**Drainage Report For
The Pines Phase I**

Subject: Response Letter to First Submittal Review Comments for
The Pines Phase I Preliminary Plat, PRV-05066
Presidio Engineering Job No.: 104023-03-0105

Re: The Pines Phase I
Response to Drainage Report Review Comments

**FIGURE 3:
ONSITE DRAINAGE PLAN**

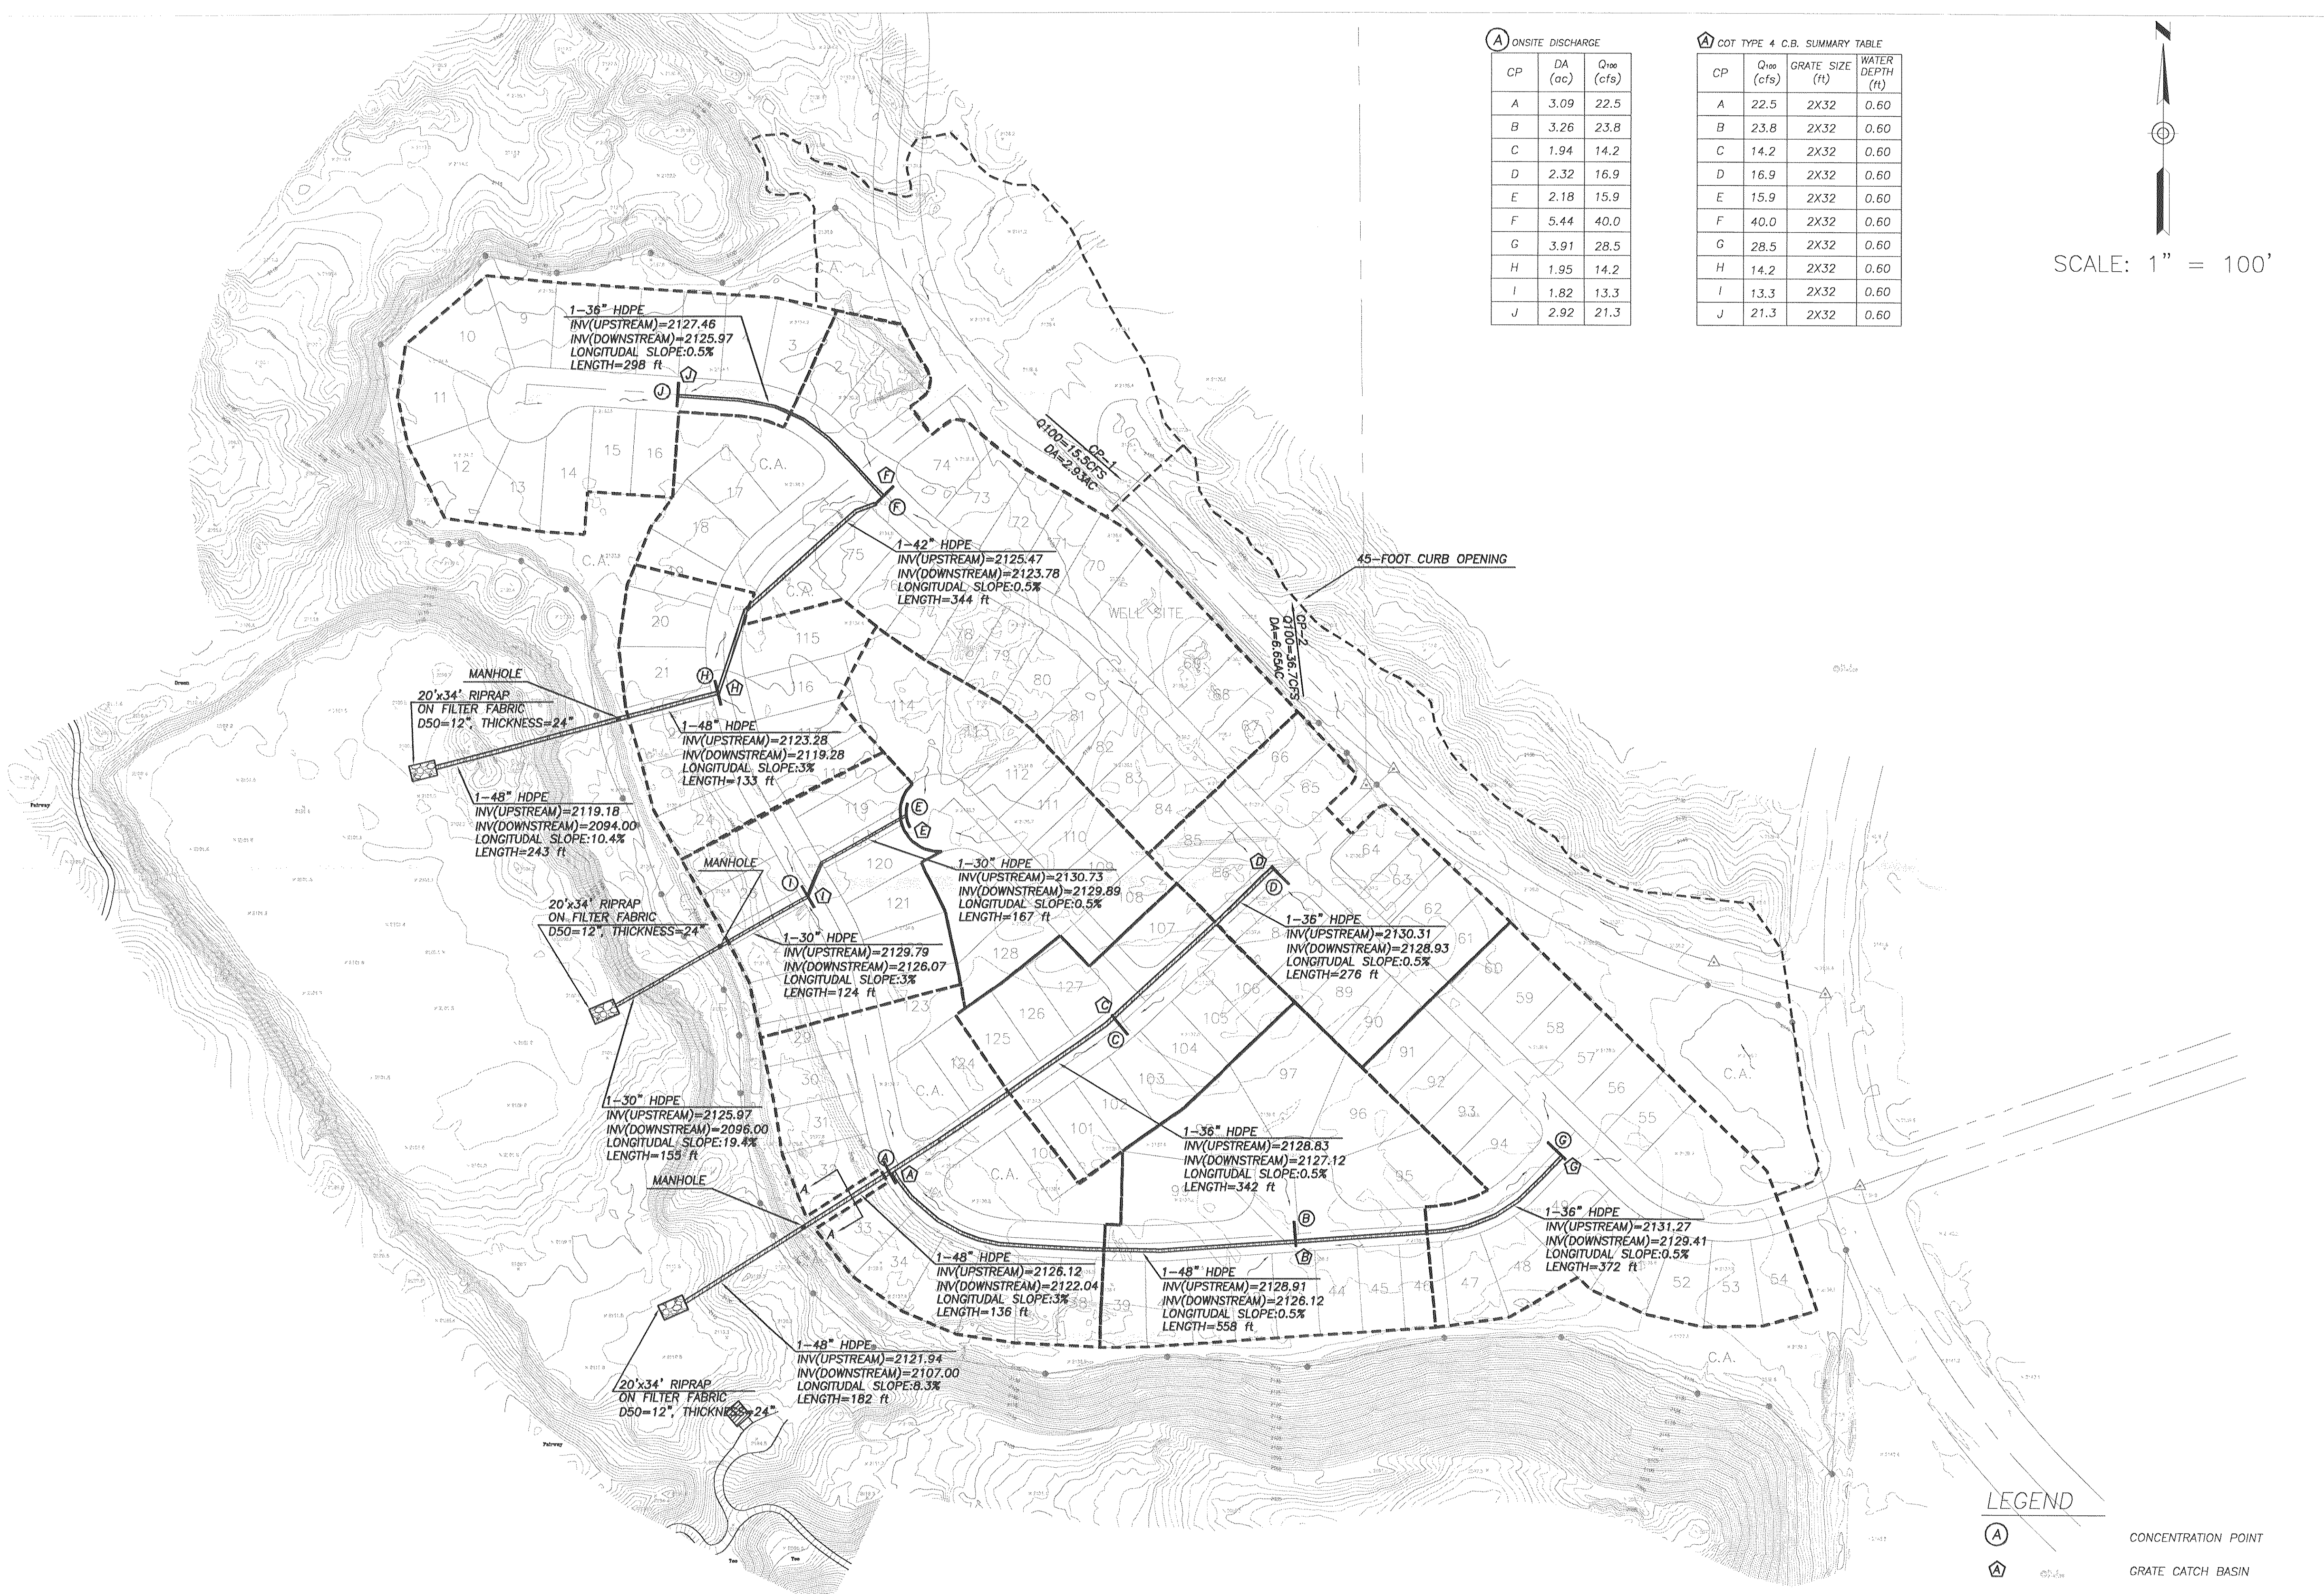
Comment 1: Please provide flow arrows on Fig 3.

Comment 3: The watercourse lengths in the drainage report appear longer than what can be scaled from Figure 3 for the various concentration points, please revised.

Response: Flow arrows are added on Figure 3.

Response: All the watercourse lengths for each concentration point are checked and revised if necessary.
